REMARKS

B. OBJECTION TO THE DRAWINGS

AMENDMENTS TO THE DRAWINGS

FIG. 1

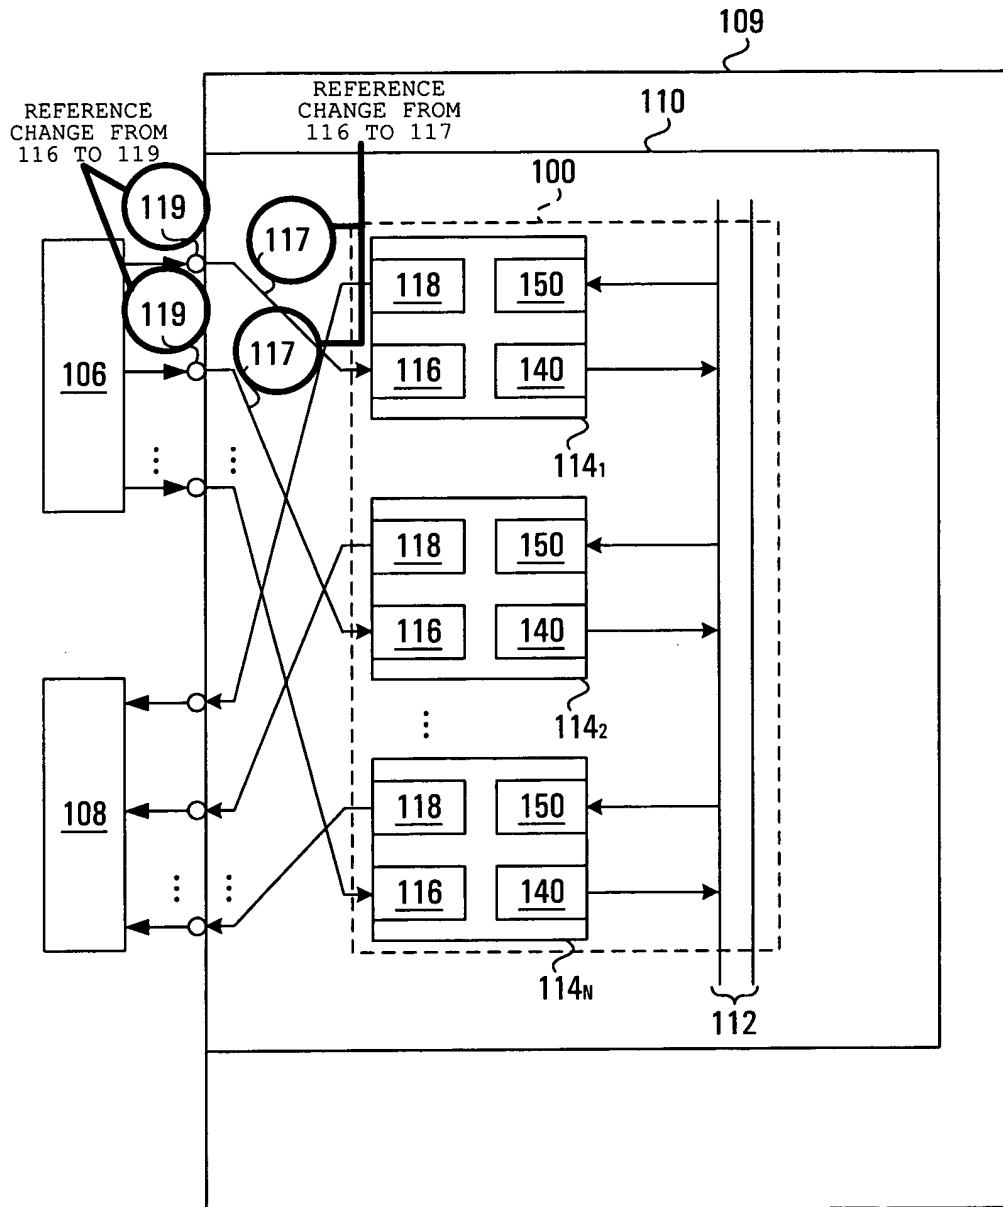
The Examiner has objected to Fig. 1 for using reference numbers " 116' " and " 116" " containing inverted commas. In response, the Applicant has amended Fig. 1 and the accompanying portion of the description such that "traces 116" " and "releasable connector 116' " have been replaced by "traces 117" and "releasable connector 119", respectively.

In Fig. 1, reference signs 116'' and 116' have been changed to 117 and 119, respectively.

FIG. 5

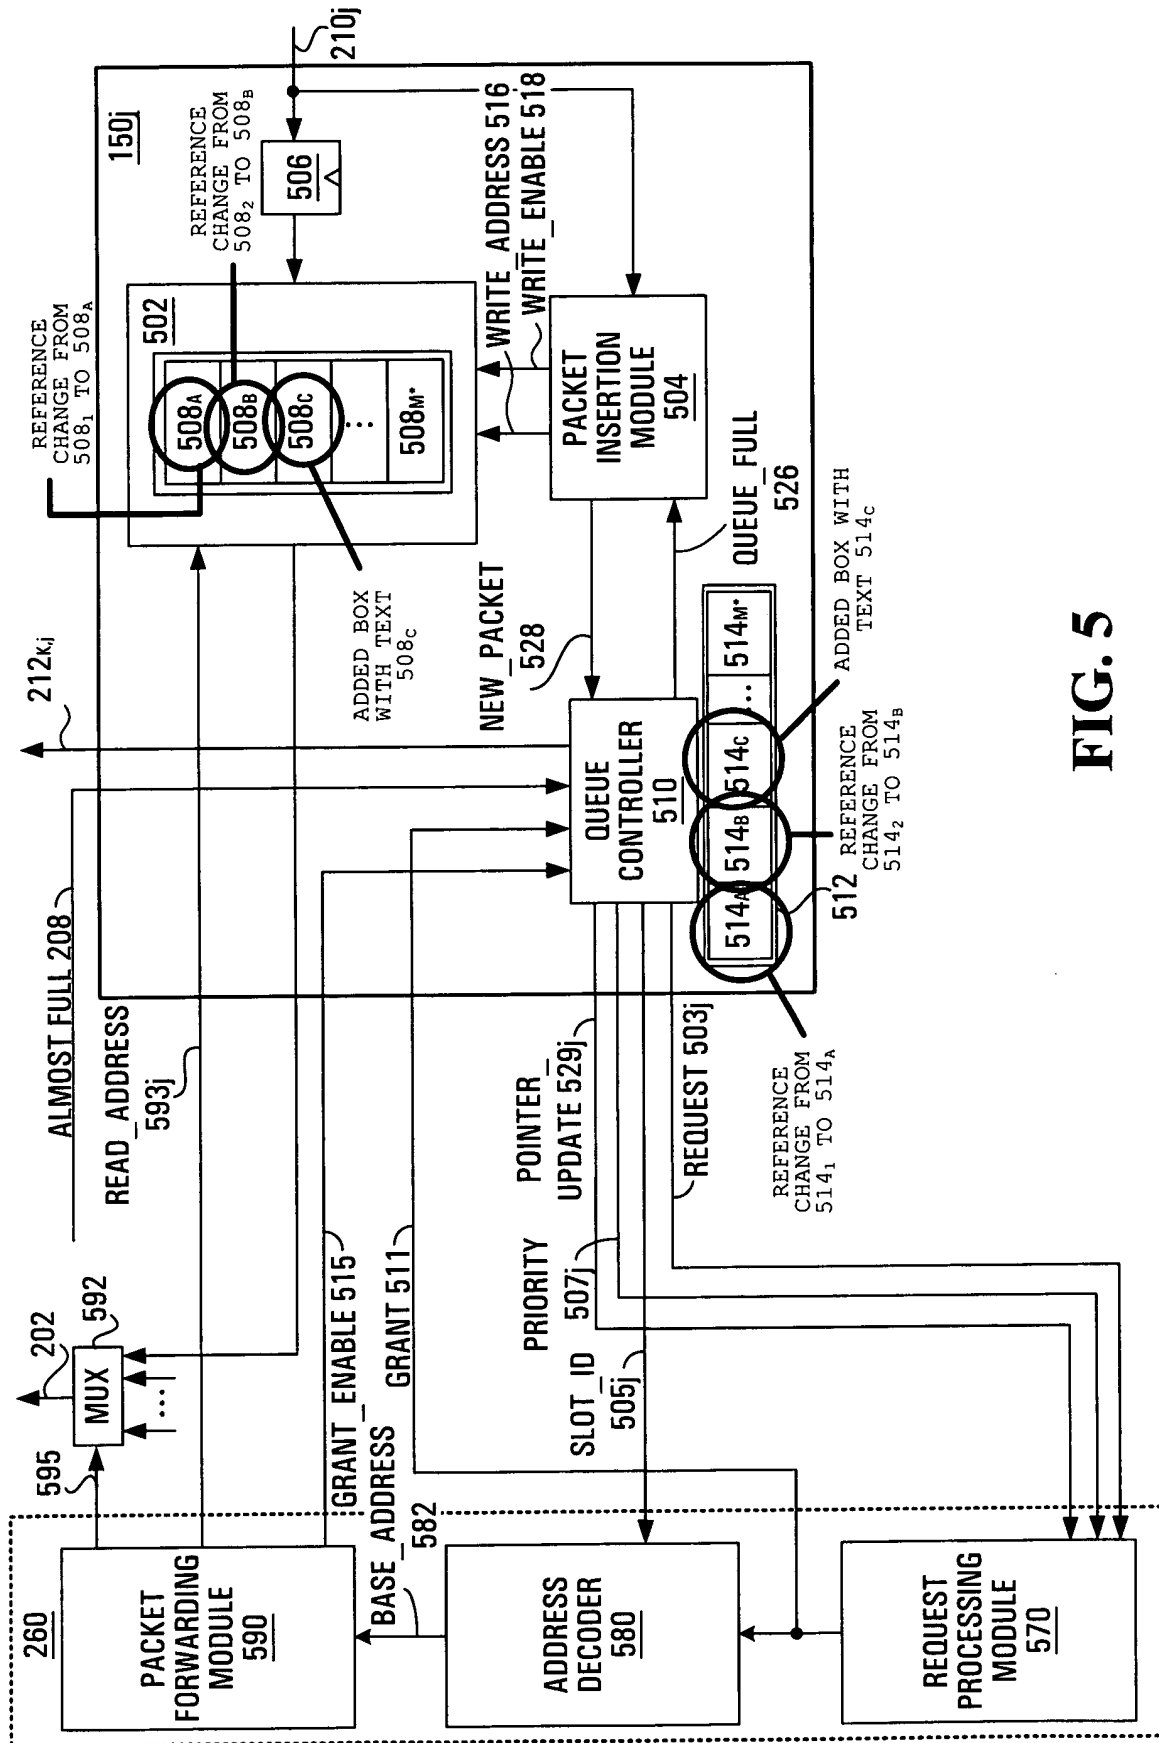
The Examiner has objected to Fig. 5 for failing to include the reference signs corresponding to "slots 508_A, 508_B, 508_C" and "entries 514_A, 514_B, 514_C". In response, the Applicant has amended Fig. 5 and respectfully submits that Fig. 5 is in full compliance with 37 CFR 1.84(p)(5).

In Fig. 5, reference signs 508₁ and 508₂ have been replaced with reference signs 508_A, 508_B, 508_C, and reference signs 514₁ and 514₂ have been replaced with reference signs 514_A, 514_B, and 514_C.

FIG. 9

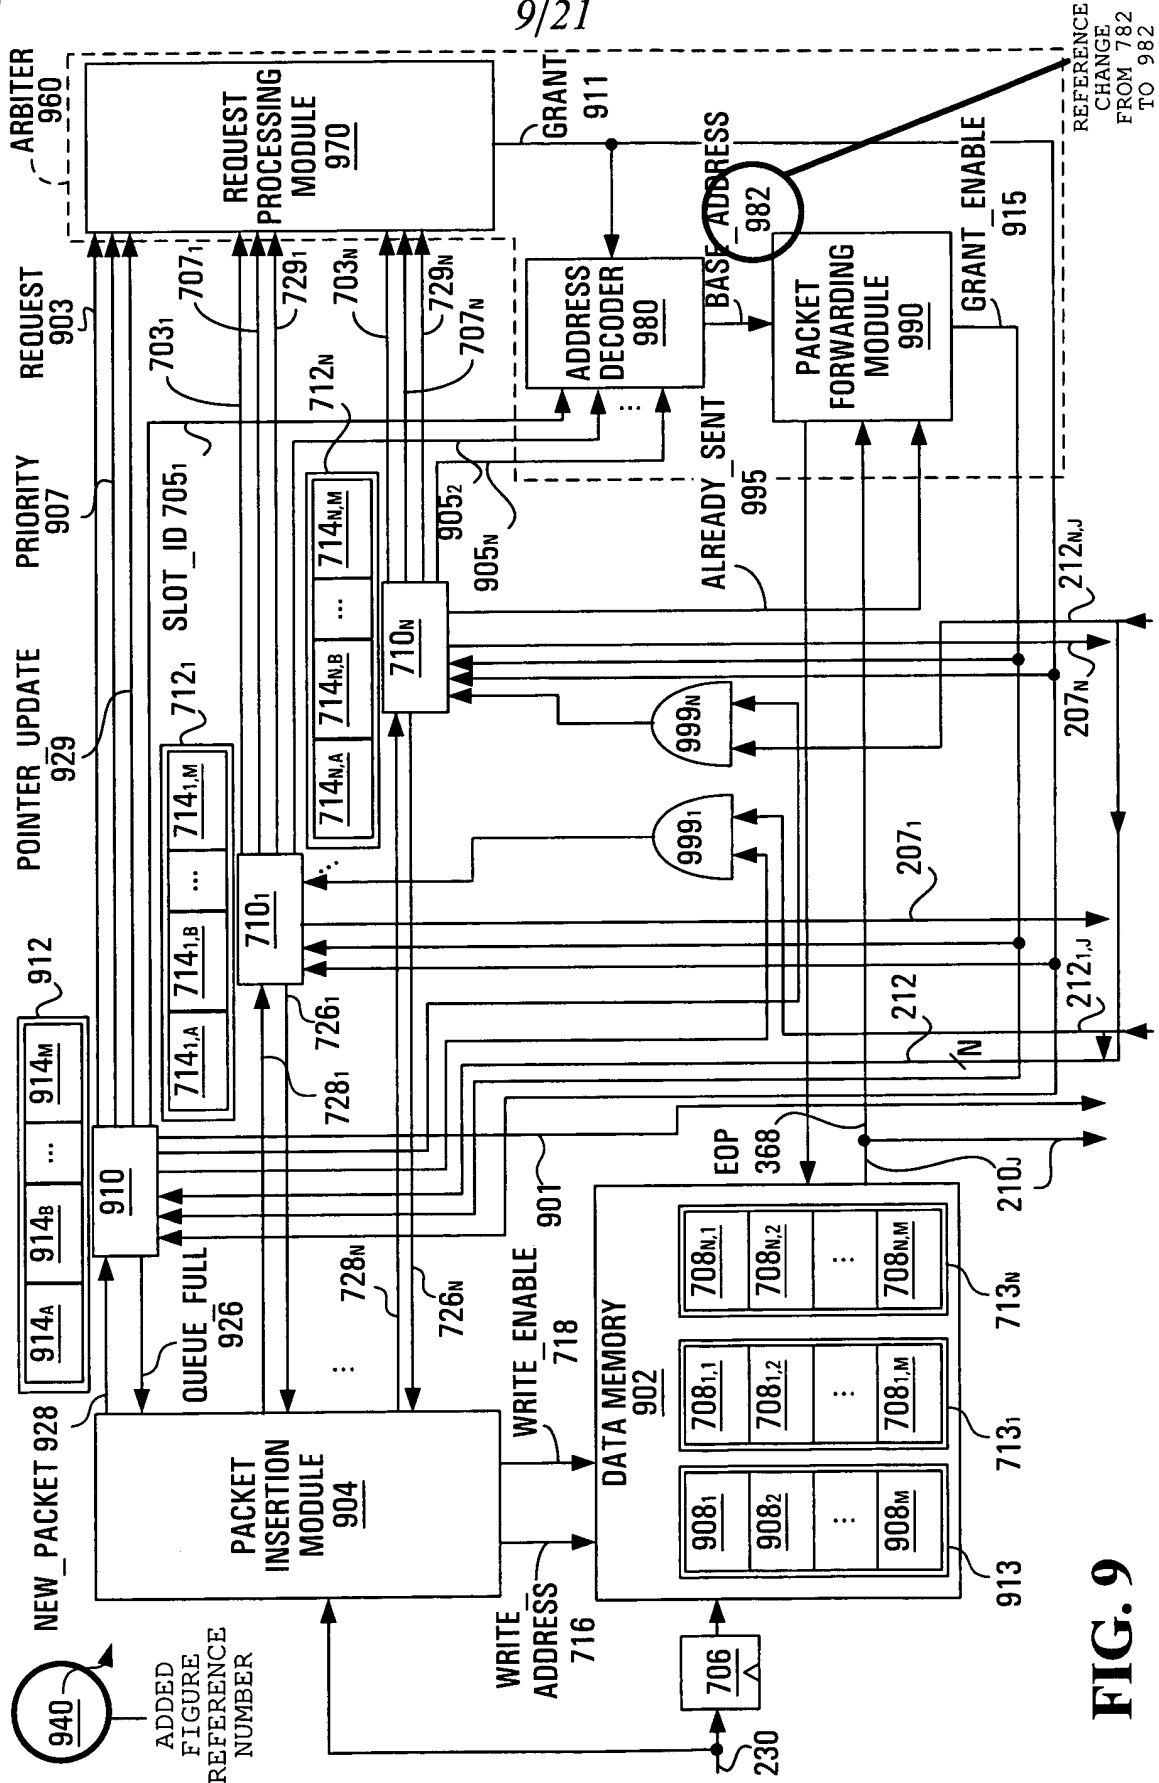
The Examiner has objected to Fig. 9 for failing to include the reference signs corresponding to "transmitter 940" and "base_address line 982". In response, the Applicant has amended Fig. 9 and respectfully submits that Fig. 9 is in full compliance with 37 CFR 1.84(p)(5).

In Fig. 9, reference sign 940 has been added to refer to the entirety of the Figure and reference sign 982 has been added to refer to the BASE_ADDRESS line.

FIG. 14

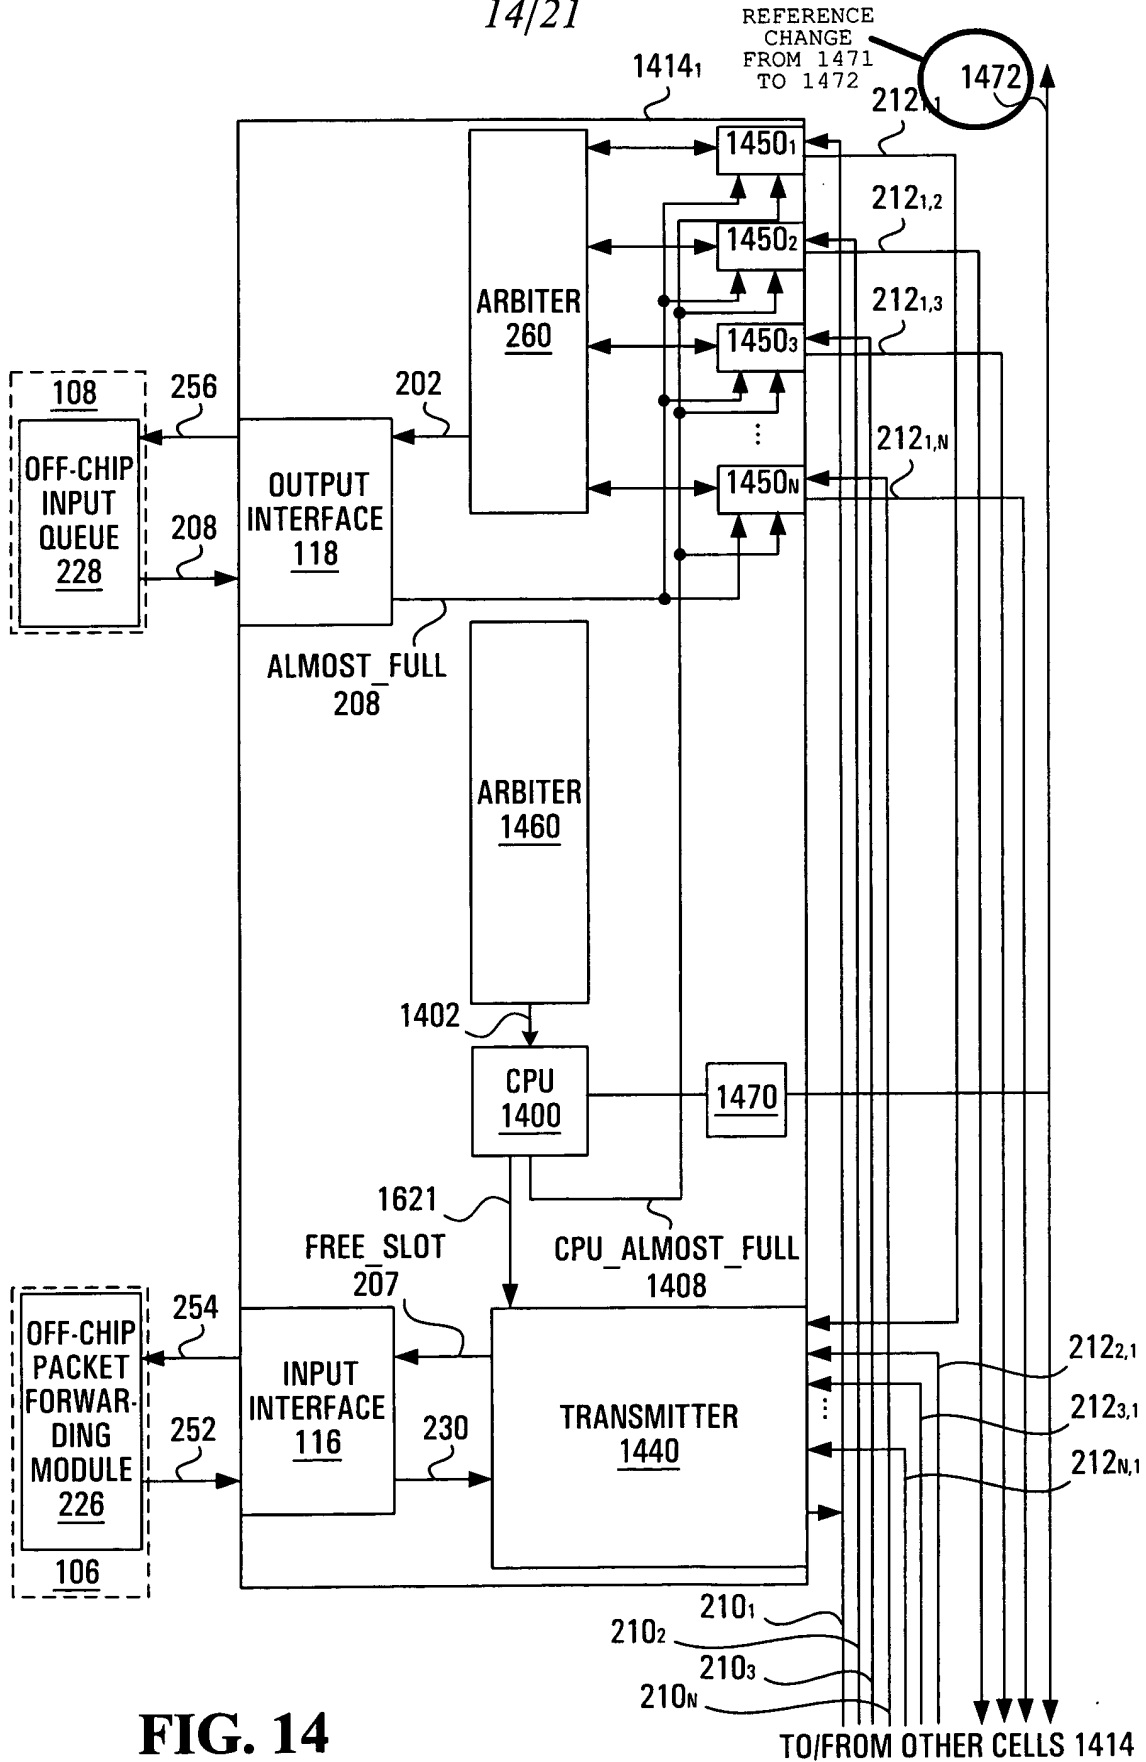
The Examiner has objected to Fig. 14 for failing to include the reference signs corresponding to "bus 1472". In response, the Applicant has amended Fig. 14 and respectfully submits that Fig. 14 is in full compliance with 37 CFR 1.84(p)(5).

In Fig. 14, reference sign 1472 has been added to refer to the bus on the far right-hand side of the Figure.

FIG. 20

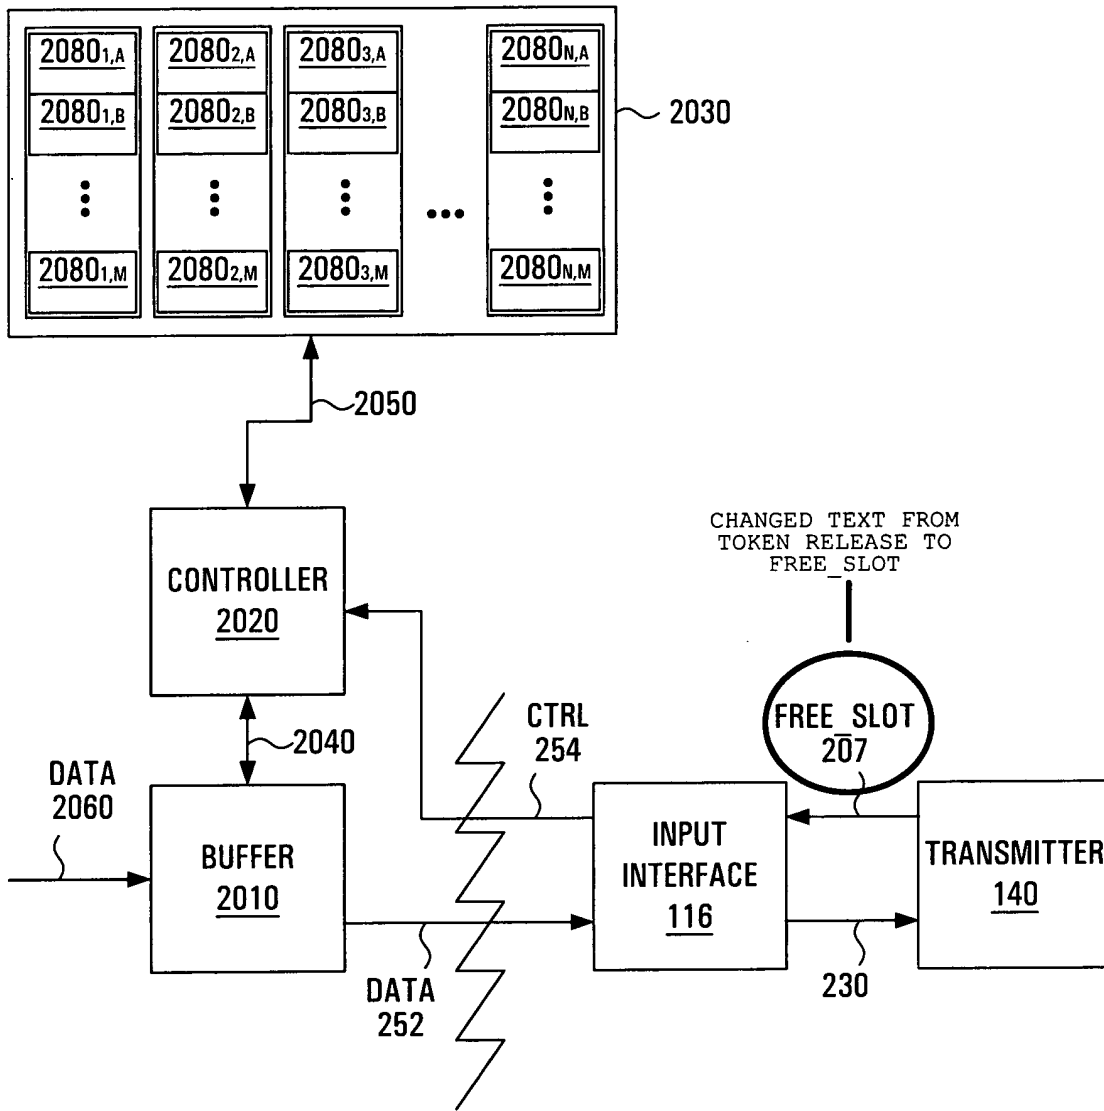
The Examiner has objected to Fig. 20 for failing to include the reference signs corresponding to "free_slot lines 207". In response, the Applicant has

amended Fig. 20 and respectfully submits that Fig. 20 is in full compliance with 37 CFR 1.84(p)(5).

In Fig. 20, reference sign 207 has been added to the free_slot line between transmitter 140 and input interface 116.
